S E R V I C E N O T E

E2500B Frequency Agile Signal Simulator (8791 Model 11)

Modification of the Line Voltage Operating Range**To Be Performed By:** Agilent-Qualified Personnel**Parts Required:**

DATE: 01 December 1991

Figure 1. Label Location for 86791A Agile Carrier Synthesizer

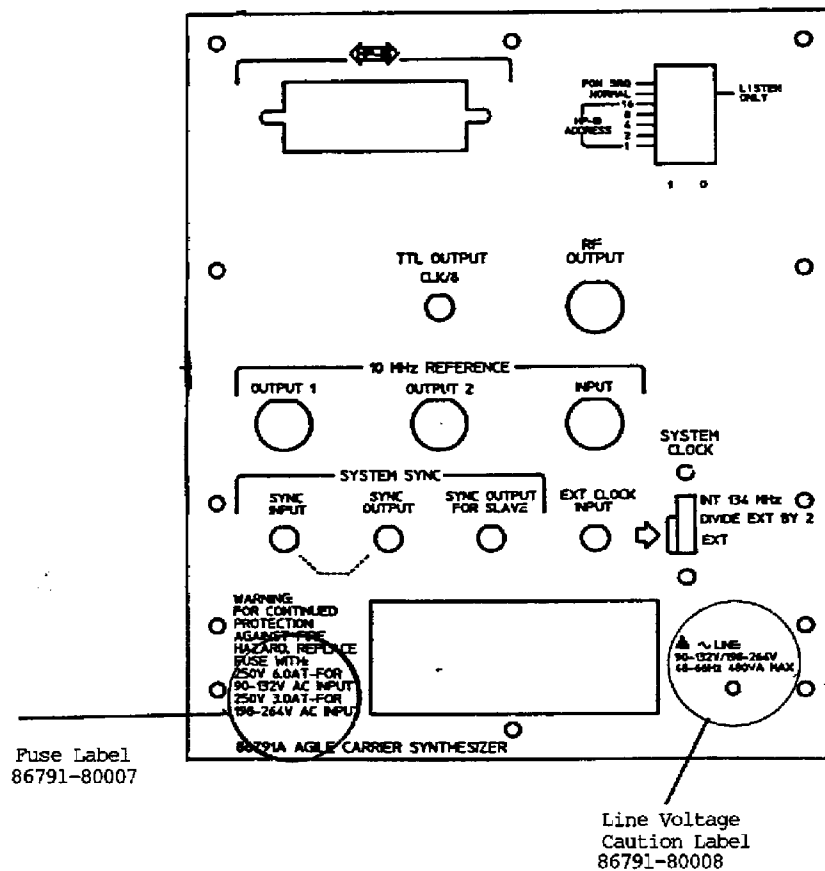
Refer to Figure 1 for placement/location of the labels part number 86791-80007 and 86791-80008.

Figure 2. Rear Door Cautionary Line Voltage Label Location

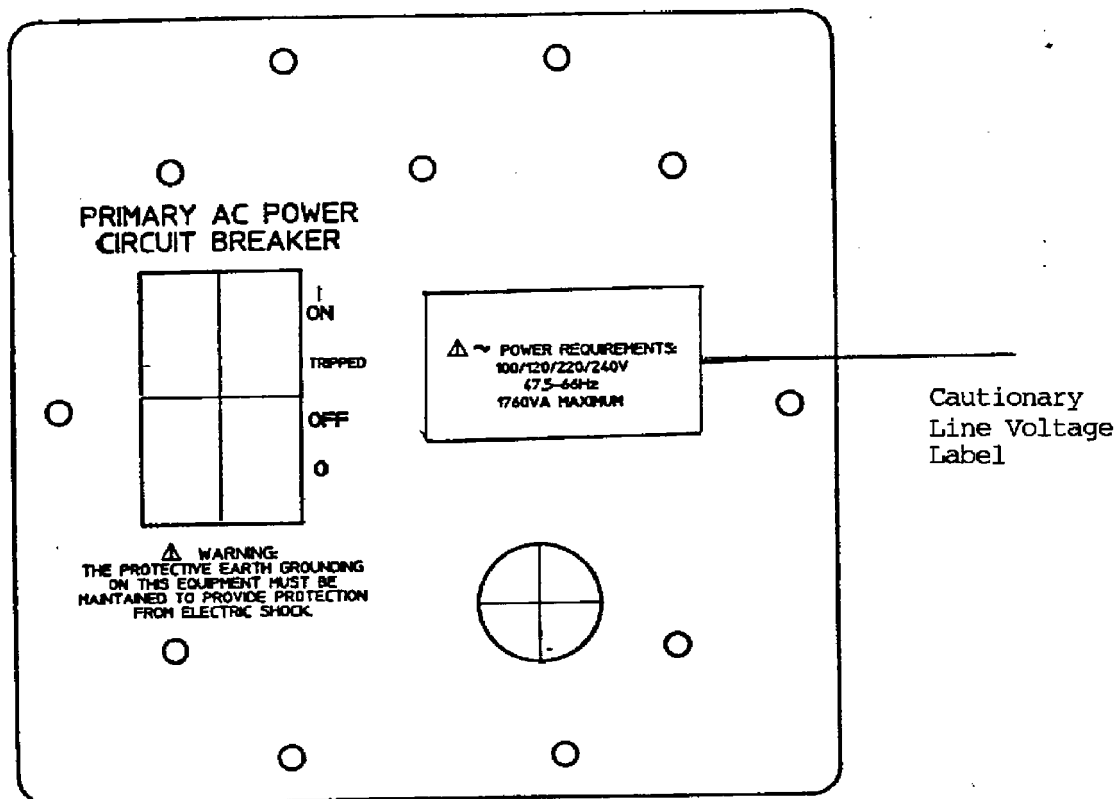
Once the power supply has been changed, it will be necessary to remove the cautionary voltage label from the rear door of the system cabinet that specified the limited operating range. Refer to Figure 2 for the location of the cautionary voltage label on the system cabinet rear door.
